Technical Service Bulletin

Topic	Failure of the Door Subframe Mounting Housing Continental GT/GTC & Flying Spur
Market area	Bentley: worldwide (2WBE),China 796 VW Import Comp. Ltd (Vico), Beijing (6796)
Brand	Bentley
Transaction No.	2078709/1
Level	EH
Status	Released for publishing
Release date	Sep 8, 2025

Failure of the door subframe mounting housing

Figure 1

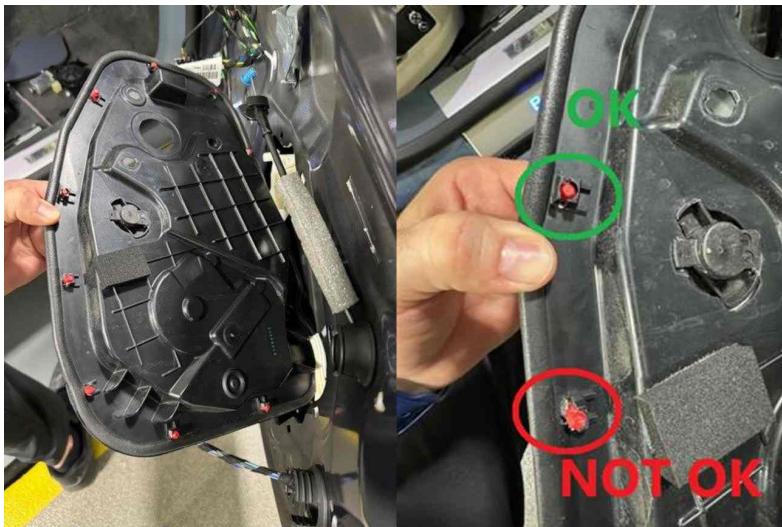
When failure of the door subframe mounting housing occurs (as shown in figure 1), the retailer is advised to order the relevant kit part (see parts information) and carry out the necessary repairs.

1. Remove the relevant door trim panel. Refer to ElsaPro, Repair Group 70
2. Remove the door power latch drive unit. Refer to ElsaPro, Repair Group 57
3. Re-fit the relevant door power latch drive to the new door trim panel (see parts information)
4. Re-fit the new door trim panel, ensuring that the door power latch drive unit has been re-used from the old assembly part. Refer to ElsaPro, Repair Group 70.

Figure 2 – Comparison between the old part and new part

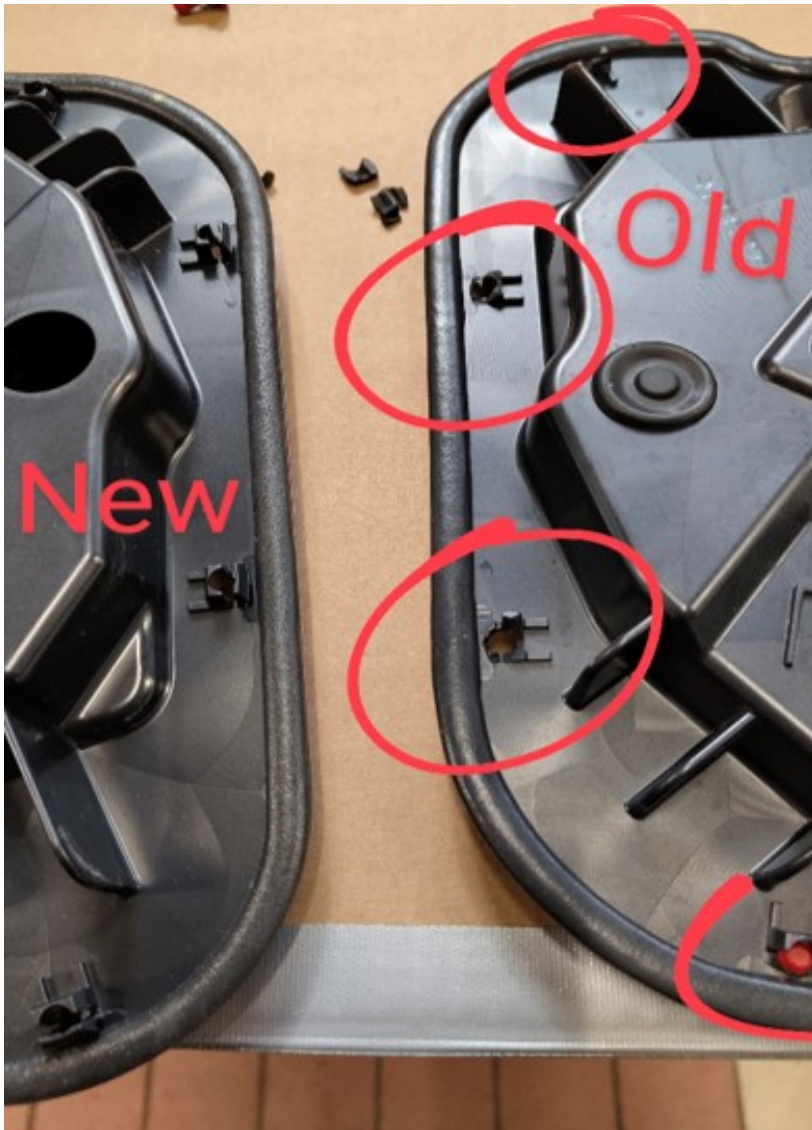
A new kit part has been created, to prevent replacement of the full assembly (including the latch motor) when the door subframe mounting housing suffers a failure.

3SD 898 308 – LH Cover for inner door panel kit (Continental GT/GTC door)

3SD 898 308 A – RH Cover for inner door panel kit (Continental GT/GTC door)

3SE 898 308 – LH Cover for inner door panel kit (Flying Spur front door)

3SE 898 308 A – RH Cover for inner door panel kit (Flying Spur front door)

3SE 898 308 B – LH Cover for inner door panel kit (Flying Spur rear door)

3SE 898 308 C – RH Cover for inner door panel kit (Flying Spur rear door)
